VIRGINIA ELECTRIC AND POWER COMPANY
SURRY POWER STATION UNITS 1 AND 2
ASME SECTION XI INSERVICE INSPECTION PROGRAM
RELIEF REQUESTS SPT-004 REVISION 2 AND SPT-003 REVISION 2
RESPONSE TO REQUEST FOR ADDITIONAL INFORMATION

Response to NRC Request for Additional Information
Relief Request SPT-004, Revision 2, Surry Unit 1 and Relief Request SPT-003,
Revision 2, Surry Unit 2

**Relief Request SPT-004, Revision 2, Surry Unit 1 and Relief Request SPT-003,
Revision 2, Surry Unit 2**

Figure 1

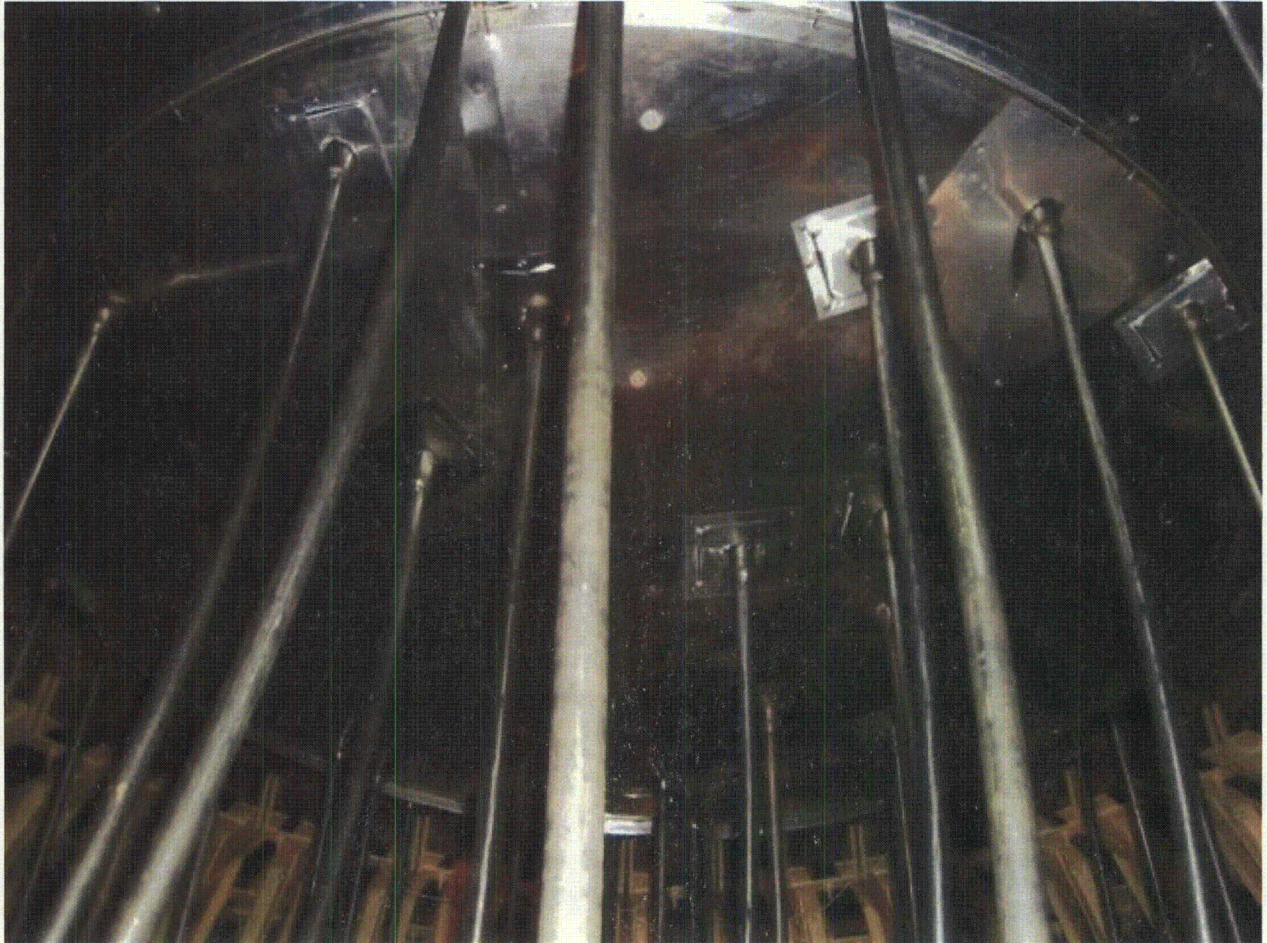
Describe the insulation configuration and the ability to see the annulus region of the nozzles even with the insulation in place.

The insulation at the bottom of the reactor vessel consists of reflective metal insulation (RMI) that conforms to the shape of the reactor vessel. The RMI has holes where each of the guide tubes exit the bottom of the reactor vessel. The insulation at the very bottom of the reactor vessel is one circular piece approximately six and half feet in diameter that can be dropped when a direct visual inspection of the reactor vessel bottom is required. The RMI is not a tight fit around each of the guide tubes and the size of the gaps around the guide tubes vary. (See Fig. 1 below.)
